CONSERVATION COMMISSION AGENDA

Date: Tuesday, December 20, 2022

2. 7:20 – 37 Truman Rd – NOI – demo/construction of SFH -- DEP #239-944

81 Albemarle Rd - approved site plan and driveway shape.

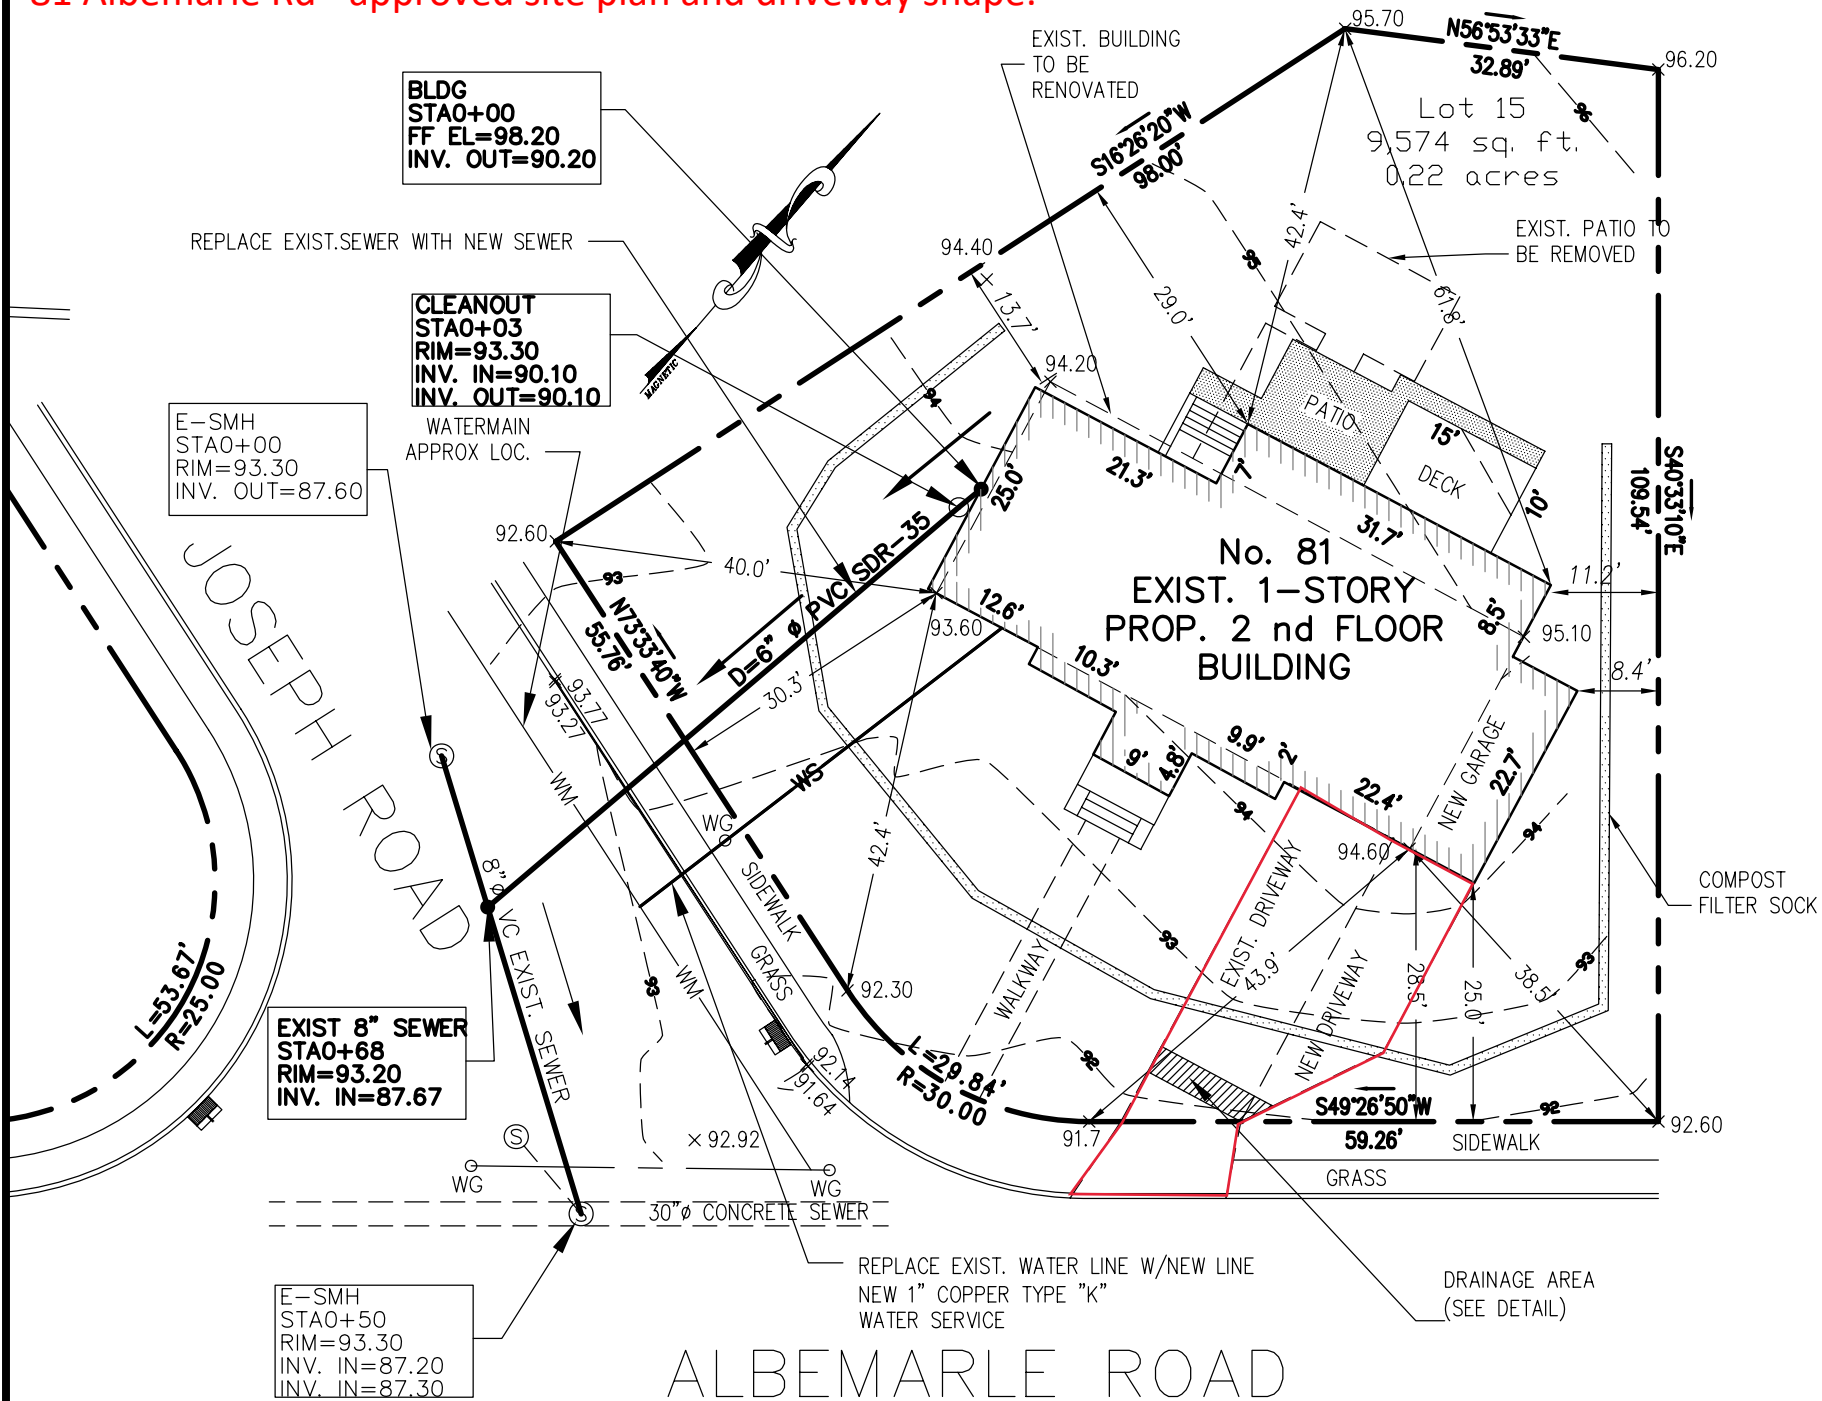
- A site visit on 11/15/22 found that the site was in substantial compliance with the approved plans except for the driveway which was installed larger than the layout on the approved plan.

- The OOC expired on 9/21/21 and so cannot be amended or extended.
 - At the 12/1/22 meeting the Commission noted that there were two options for the applicant/owner to bring the site into compliance with the regulations.

- Remove the excess asphalt
 - Submit an NOI for the driveway expansion and the installation of a permanently bounded mitigation planting area of at least 2:1.

- To ensure completion of the work, staff recommend that unless asphalt is removed right away, an Enforcement Order should be issued, regardless of the path chosen.
- Staff recommend that:
 - If the owners are going to remove the excess asphalt, an EO should suffice
 - If the owners are going to install a permanently bounded mitigation planting area, an EO and possibly an NOI/OOC should be required.
